**Flood Control Project Maintenance  
Levee Inspections**

**Maintenance Issue Types Only, Levee Inspection Report By Mile - Fall 2020**

**Reclamation District No. 0108 River Farms**

Waterway	Bank	Unit Miles	Inspection Start/End	Inspector
Unit No. 01 Colusa Basin Drain	Left	20.64	09/10/2020 09/10/2020	Zach Jojola

Photo 1 of 3 : UCIP\_FA\_2020\_55923\_83231.jpg

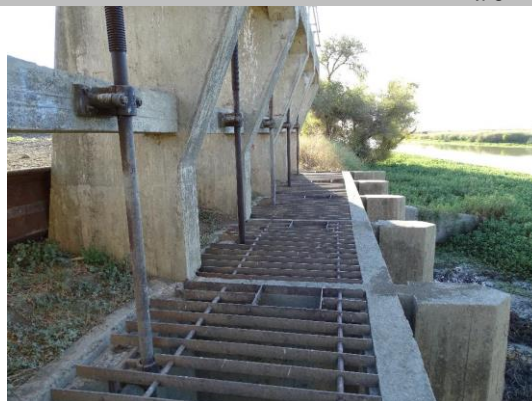
Comment Code					
Inspector Comment					
DS_ID:22389 FS_ID:55923 EP_NO: 9396 Repair Type: Non-Urgent EVAL Issue: Unauthorized Encroachment, installed decades prior Crossing Status: Found UCIP Comments: 10/2/2019 Record remains Non-Urgent. In 2019 RD 108 took an attempt to bring structure to operable condition. Although this attempt was unsuccessful District will review other options. In the meantime crossing considered abandoned. Need to have CVFPB review ABO and determine current owner. (O.Yakimov - DWR UCIP)06/10/2014 Need to contact owner to determine status of structure. Notes indicate crossing has been abandoned. Owner will need to coordinate with CVFPB and DWR inspector to determine how to properly abandon. (O.Magana - DWR UCIP) FIELD_STRUCT_DESC: *ABANDONED* 5 of 5: 72-inch reinforced concrete gravity drainage pipe or culvert through the levee, 31.6 feet below the crown. Slide gate on each end. (Retention of five 72-inch pipes through the levee [HLM 0.08] authorized under Automatic Board Order (ABO) issued as Permit No. 9736, 1974 - Reclamation District No. 108 [RD0108]). [Additional Reference(s): DWR Levee Log, 1991. USACE Sacramento O&M Manual 132, October 1959, (HLM 0.08), referenced as five 6-foot by 8-foot concrete drainage culverts]. FS Date: 10/2/2019 8:01:09 AM
